ADDENDUM NO. 2

**STOUT FIELD BUILDING 18
MILITARY INTELLIGENCE BATTALION CONVERSION
INDIANAPOLIS, INDIANA**

IFB NO: MDI-SAB-24-B-014

GEDA Architects

M502

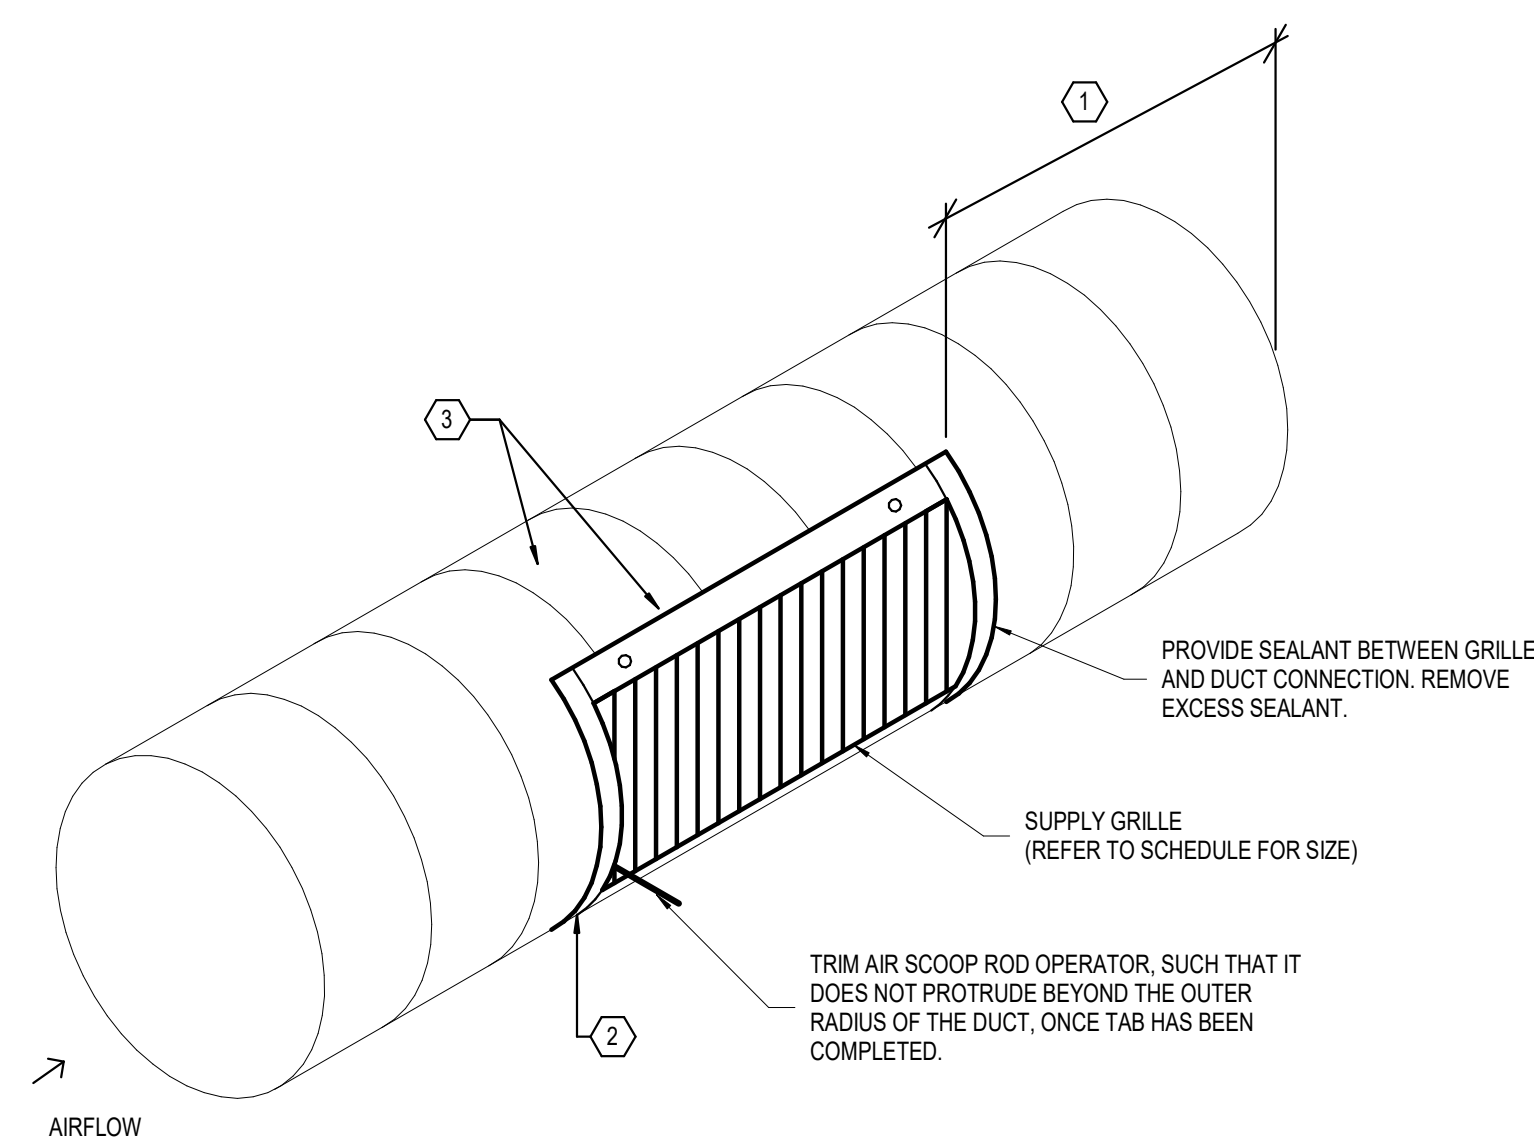
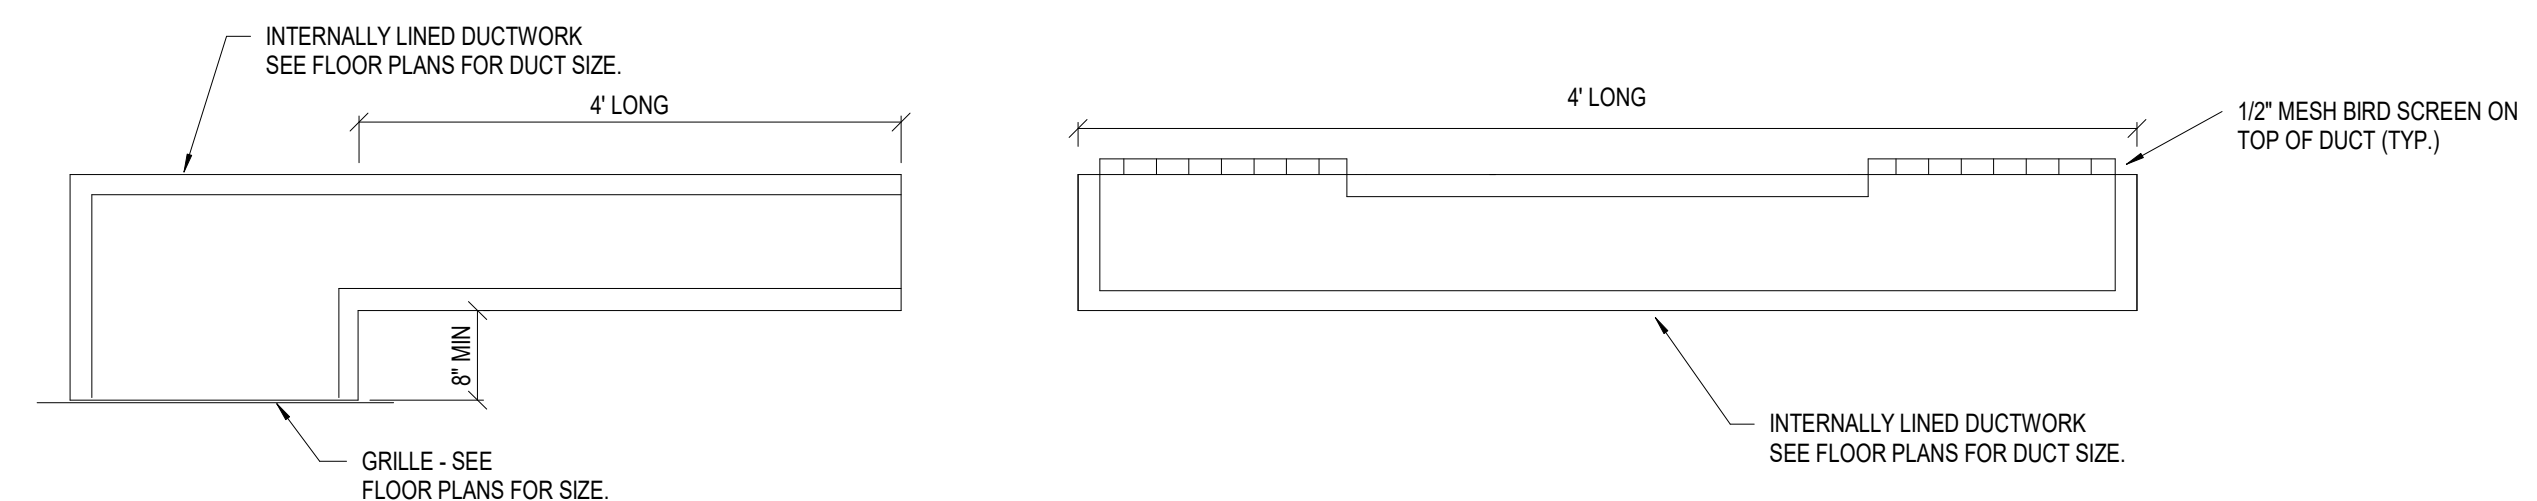
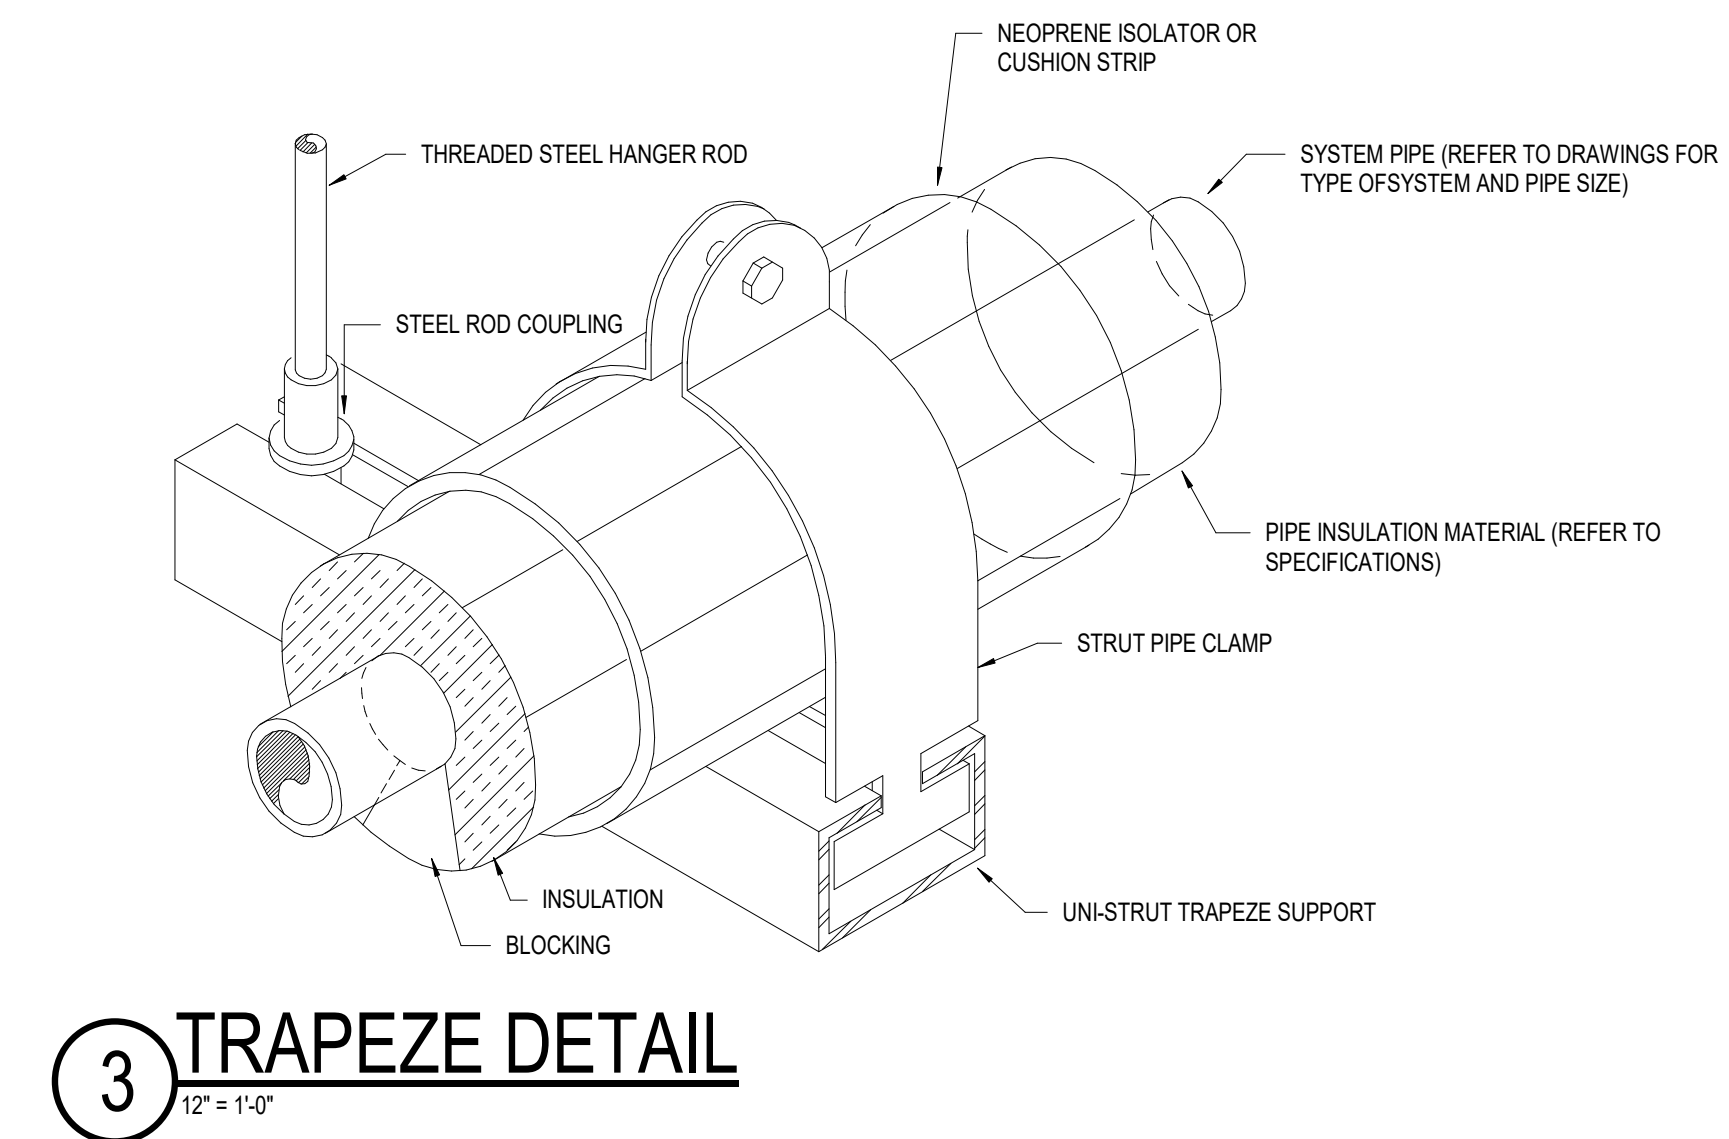
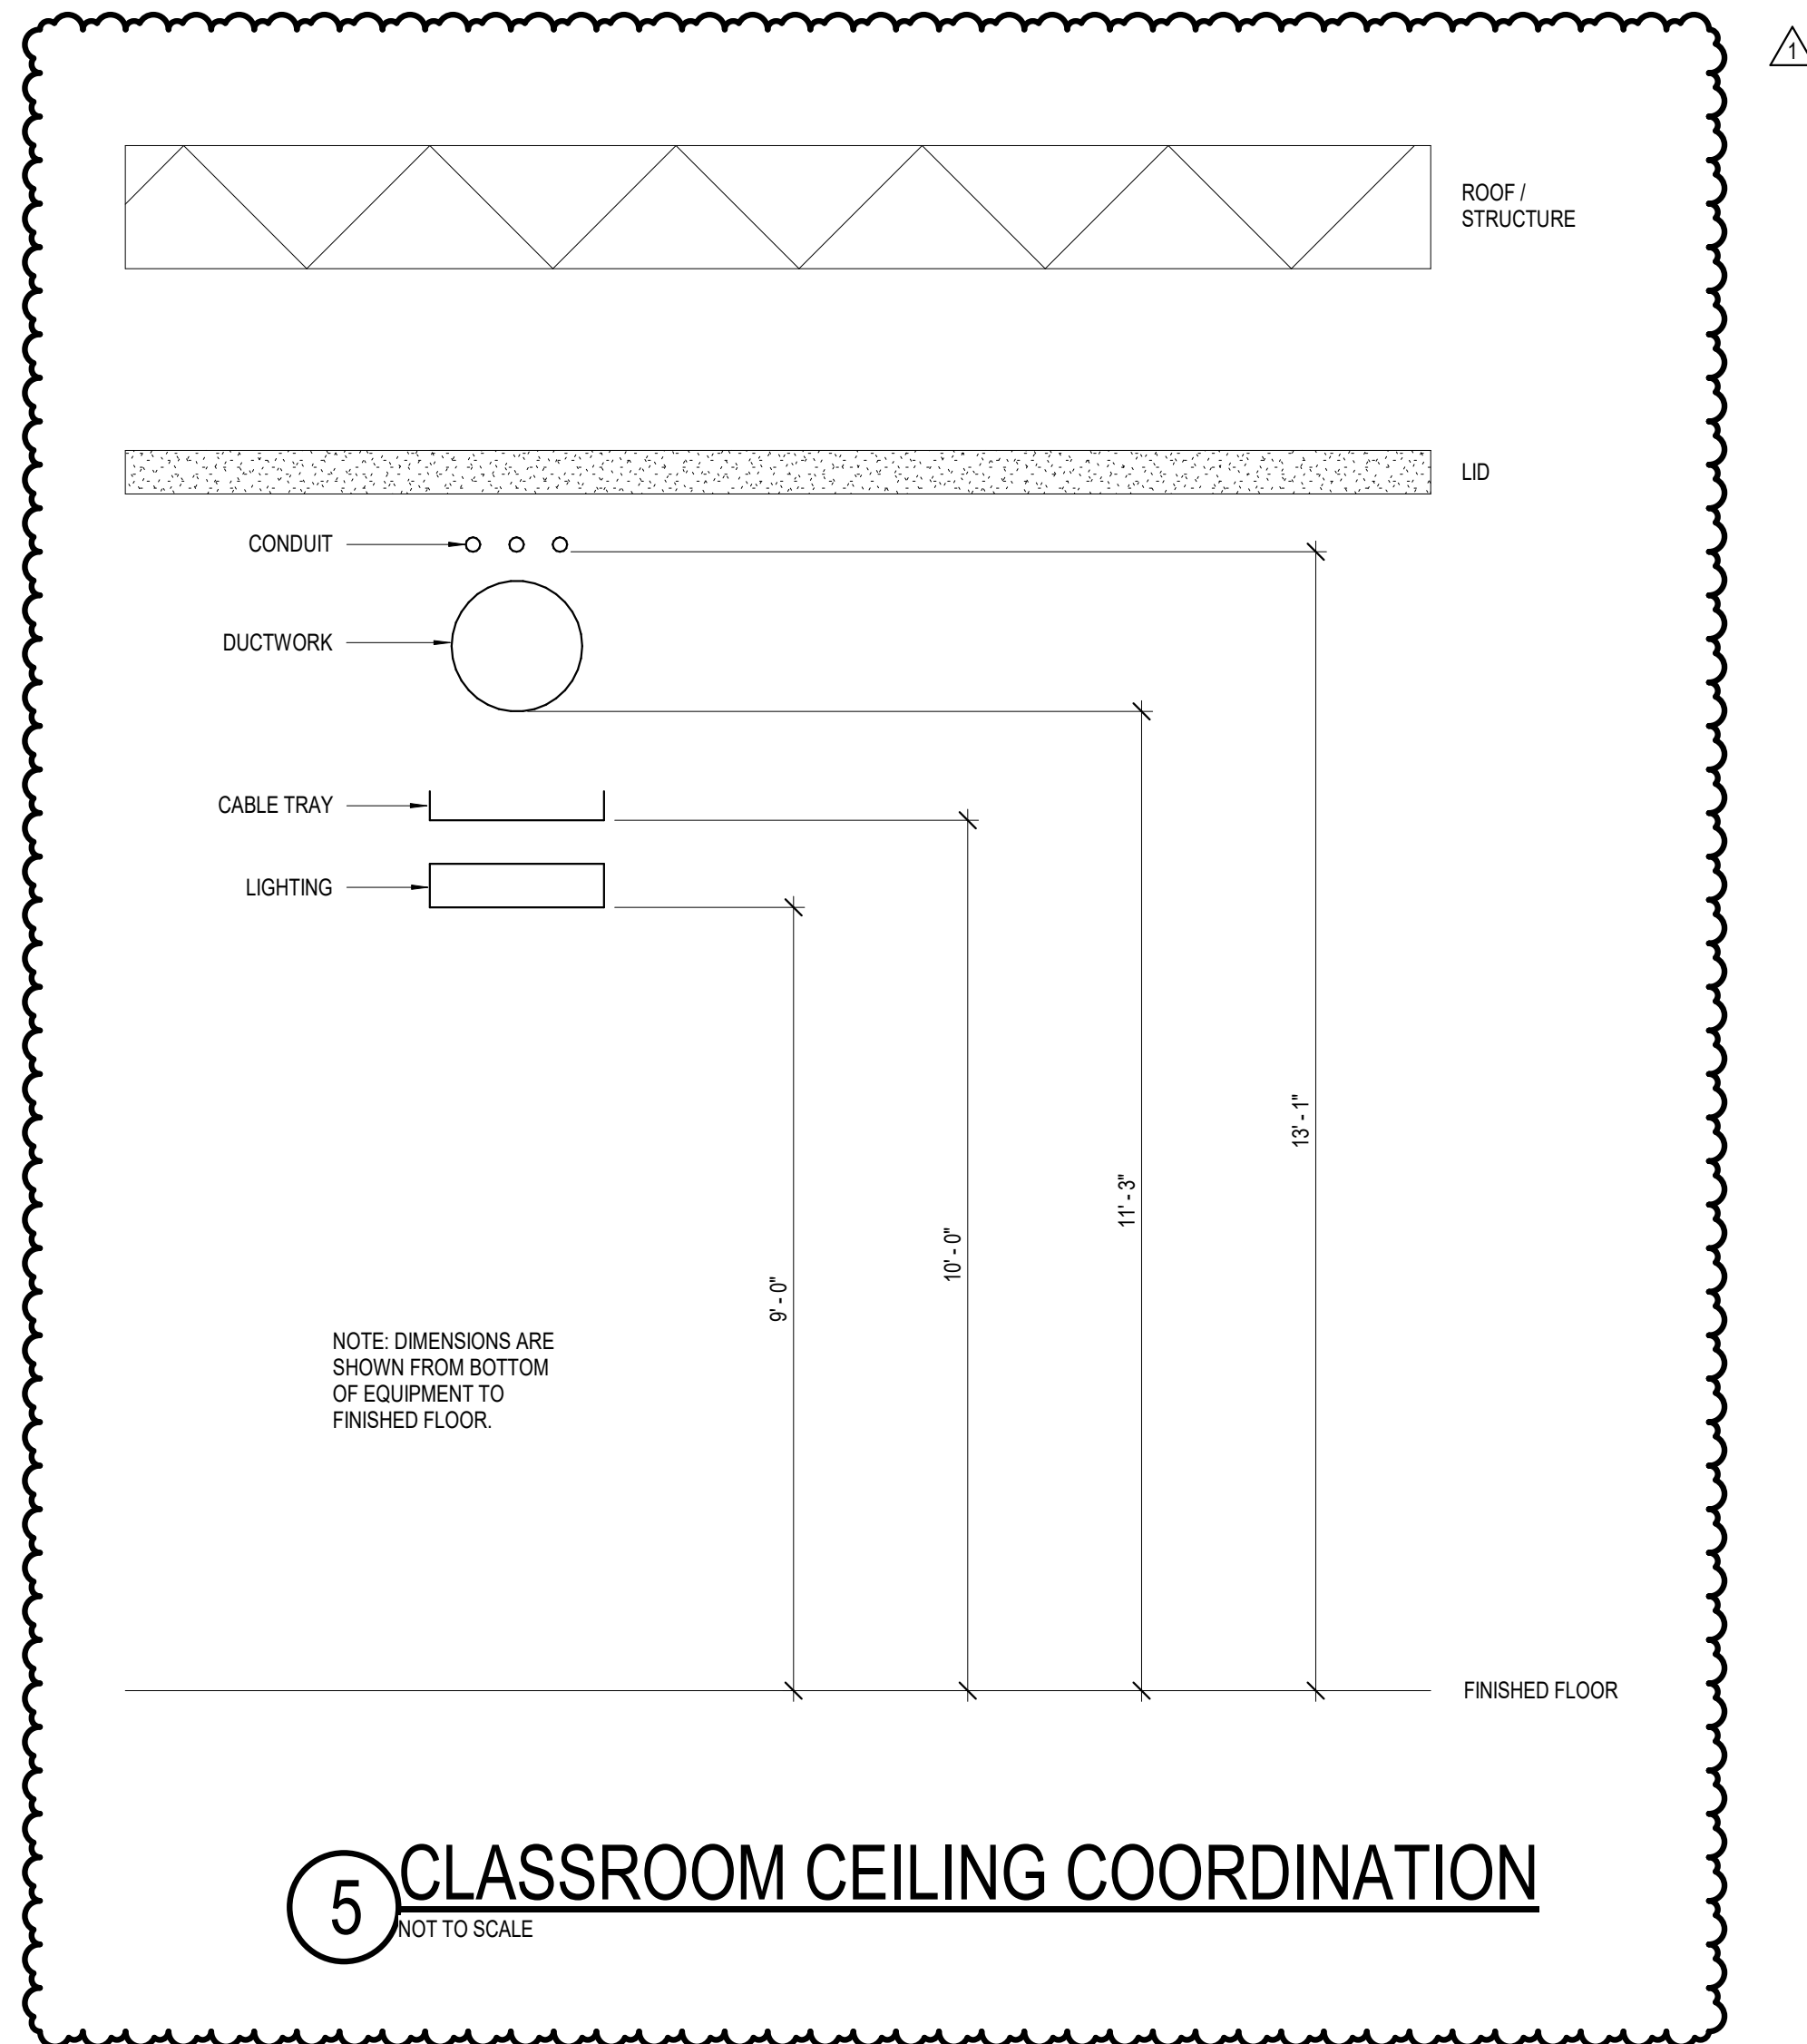
11. Sheet M502 – MECHANICAL DETAILS
 - Added detail number 5 to sheet.
